**From:** Kitchen, Robert [robert.kitchen@pgnmail.com]  
**Sent:** Friday, June 29, 2012 8:47 AM  
**To:** Habib, Donald  
**Cc:** Rose, Dana  
**Subject:** DRAFT Levy FSAR Org Charts  
**Attachments:** LNP\_FSAR\_FIG13AA\_201.pdf; LNP\_FSAR\_FIG13\_01\_201.pdf; LNP\_FSAR\_FIG13\_01\_203.pdf; bPECOLA-2-LI-012-0013-R3-F1.pdf; PECOLA-2-LI-012-0013-R3-F1.pdf; aPECOLA-2-LI-012-0013-R3-F1.pdf

Don – As discussed, attached are the current LNP FSAR organization charts and the DRAFT changes to reflect the Duke – Progress Energy merger. These changes will also be reflected in the QAPD. Let me know if you have questions. We can discuss on the public call on Thursday, 7/5/12.

Progress Energy Florida  
 Levy Nuclear Plant  
 Units 1 and 2  
 Part 2, Final Safety Analysis Report

Progress Energy Florida  
**Levy Nuclear Plant**  
 Units 1 and 2  
**Part 2, Final Safety Analysis Report**  
 Corporate and Engineering Organization  
 FIGURE 13.1-203  
 Rev 3

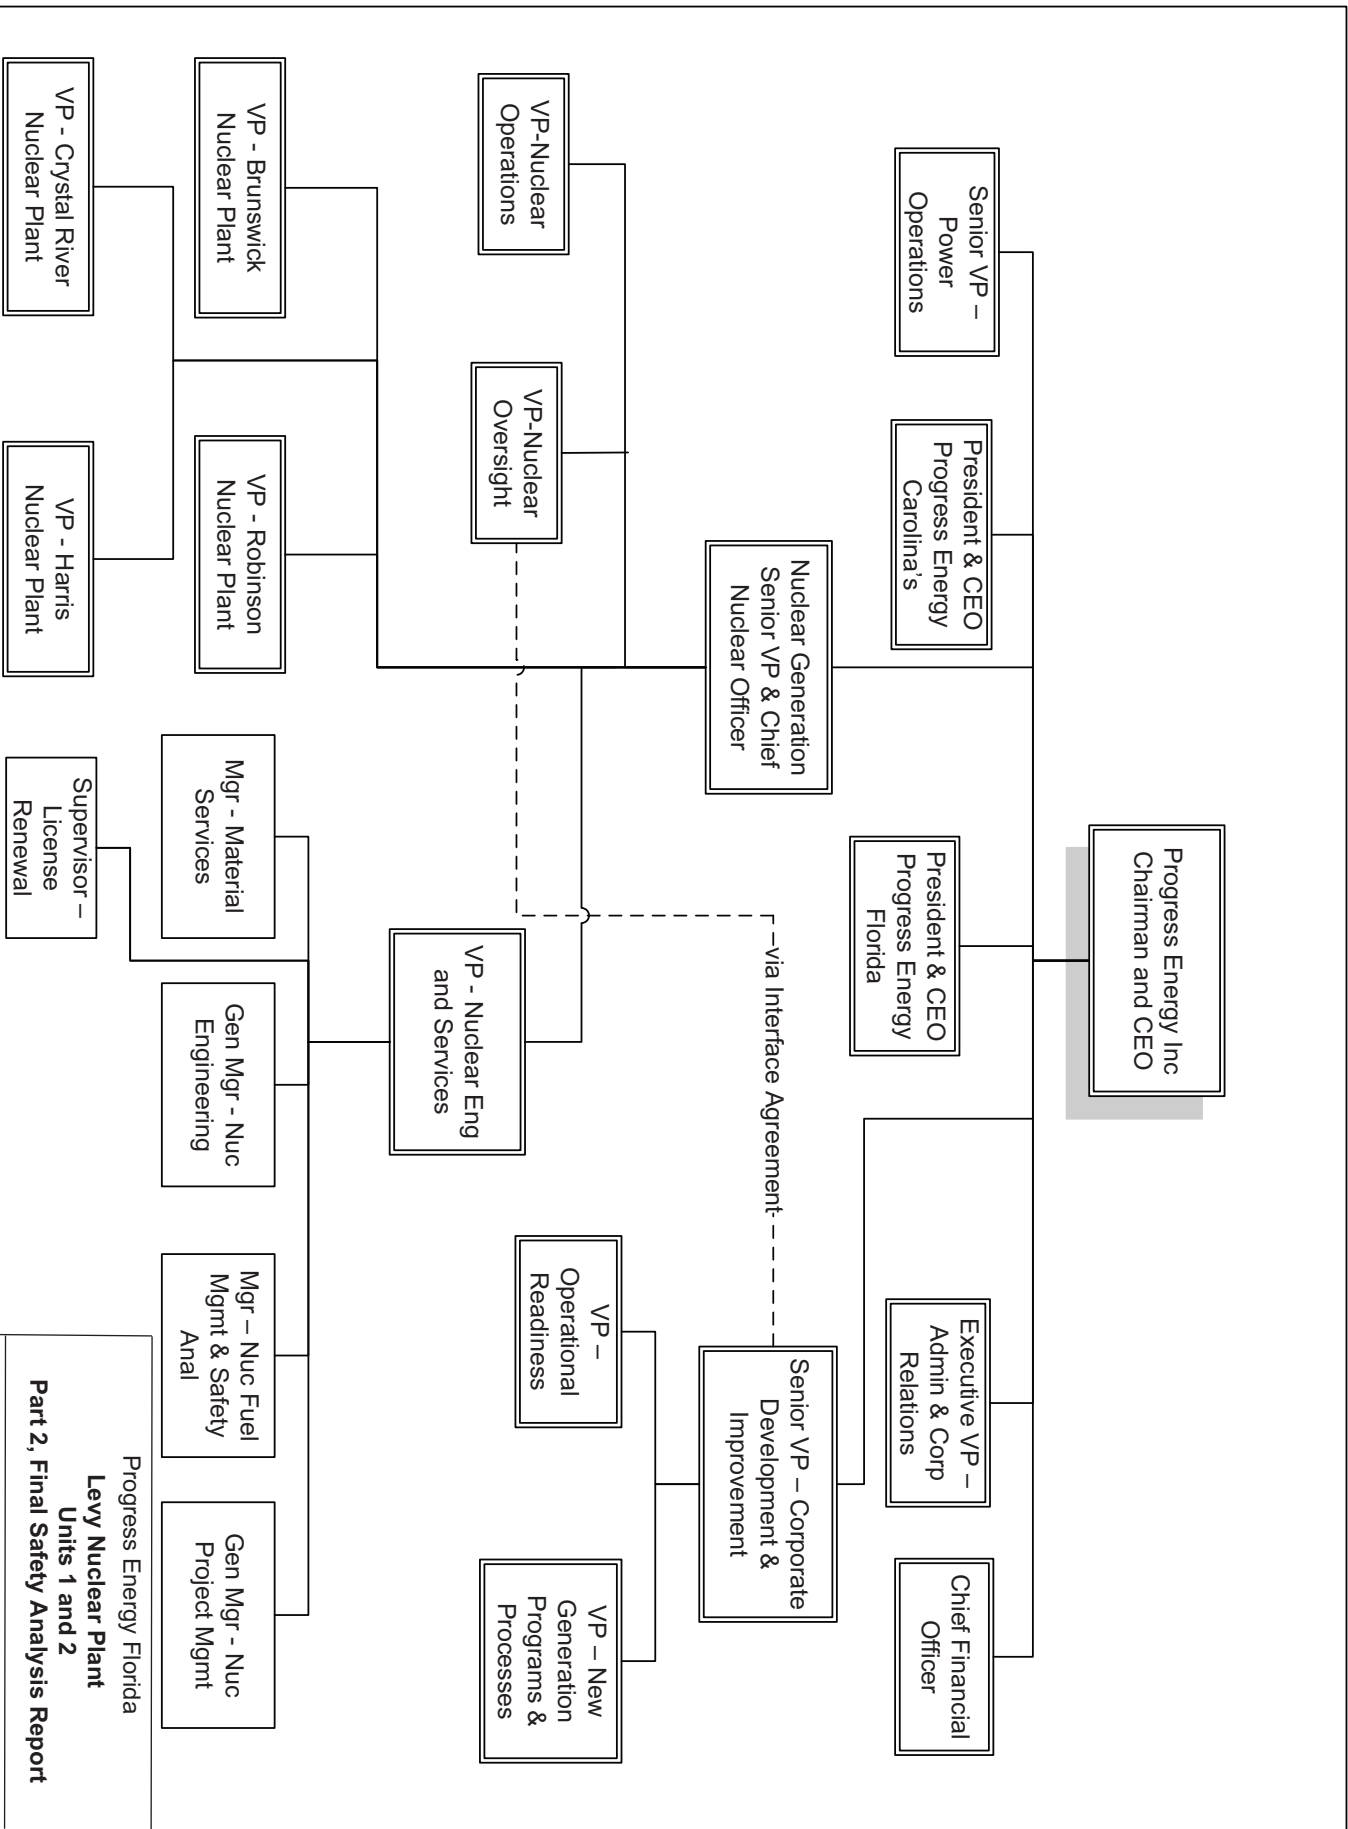
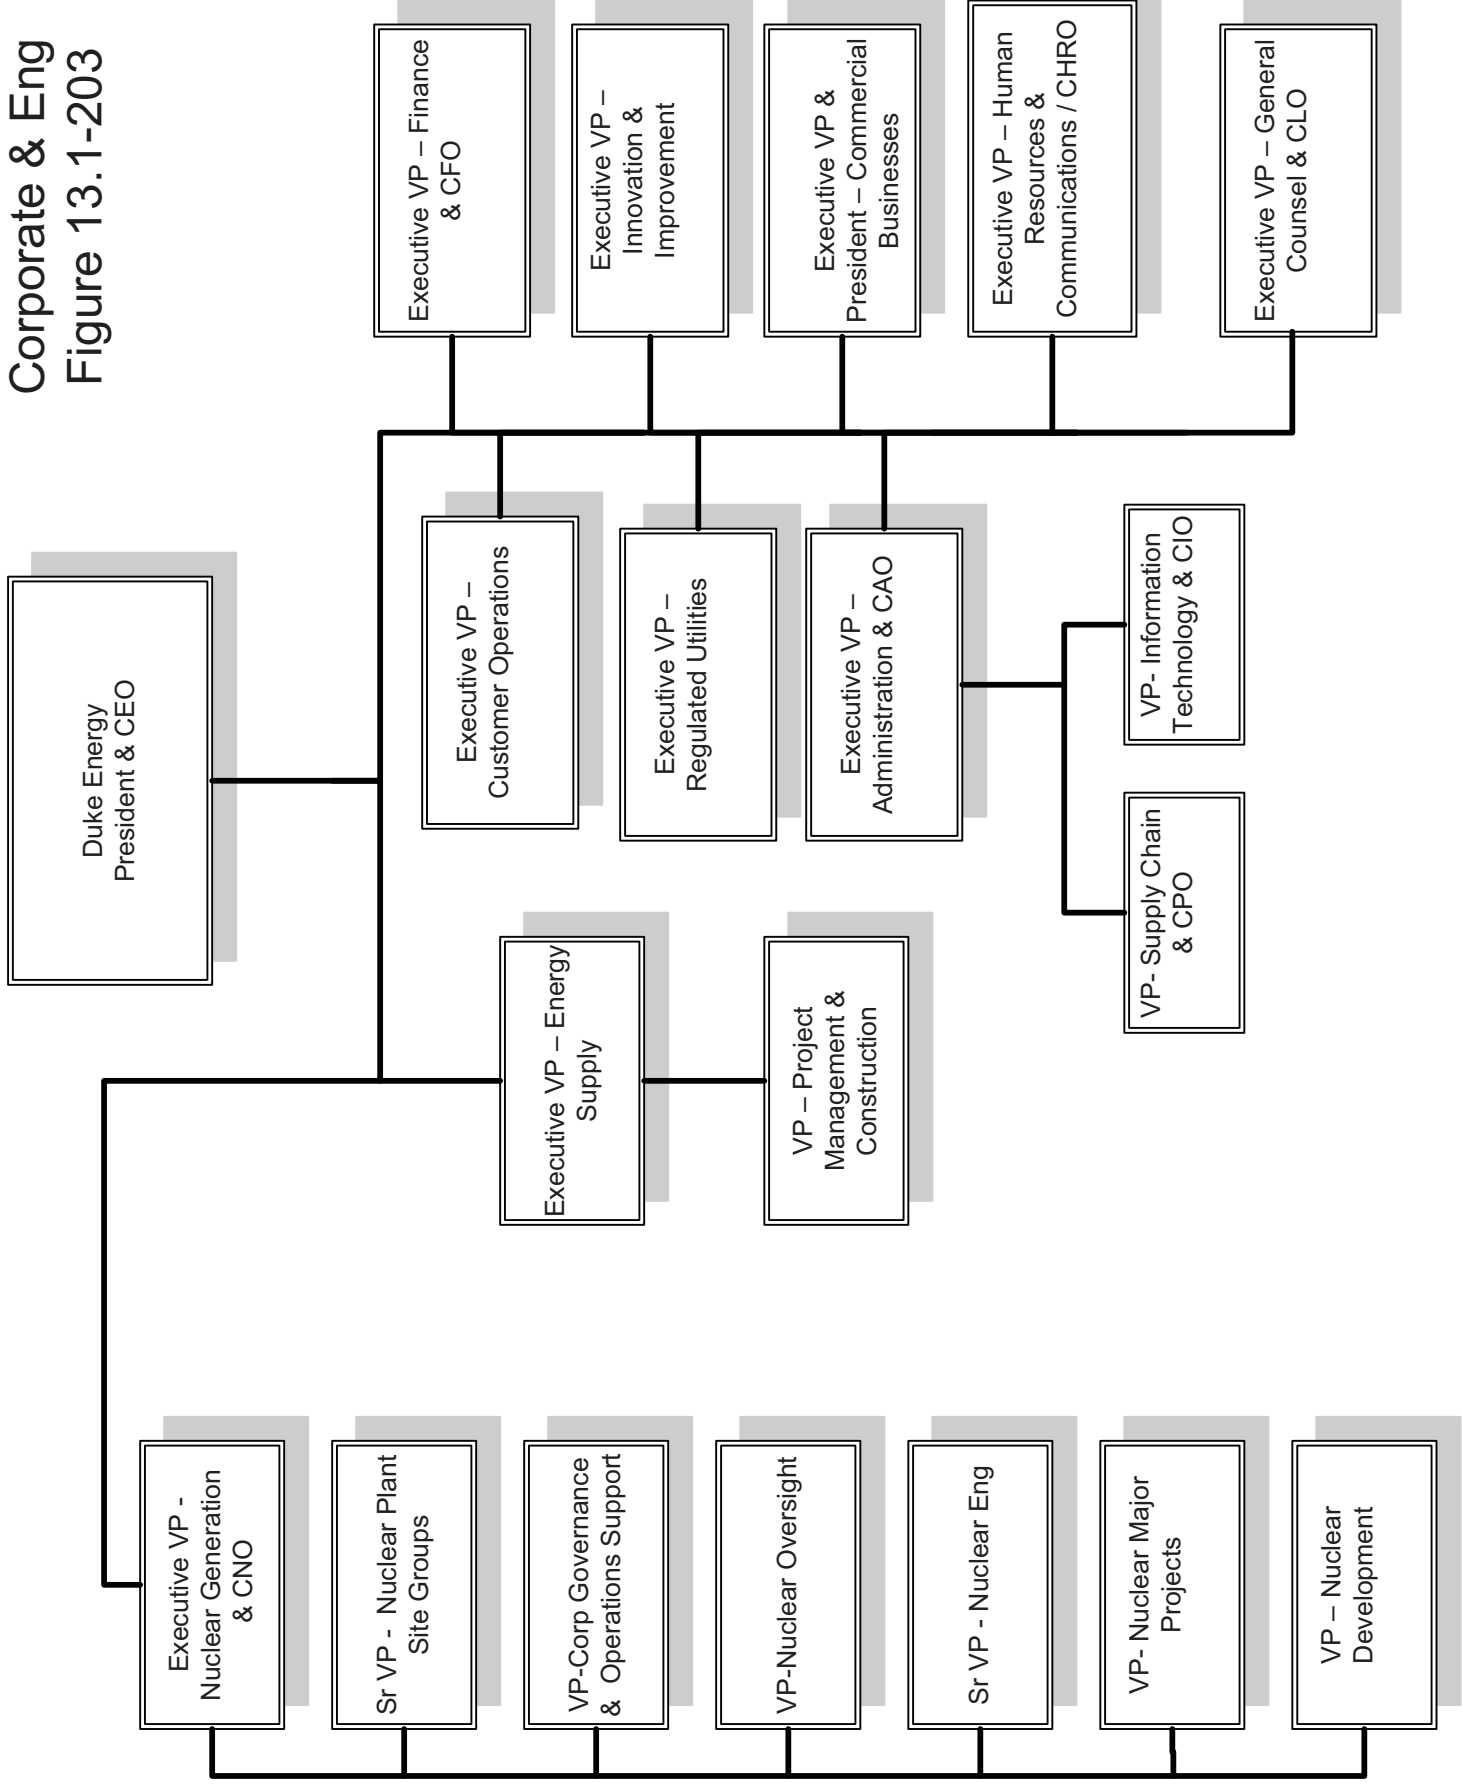
Draft  
Corporate & Eng  
Figure 13.1-203
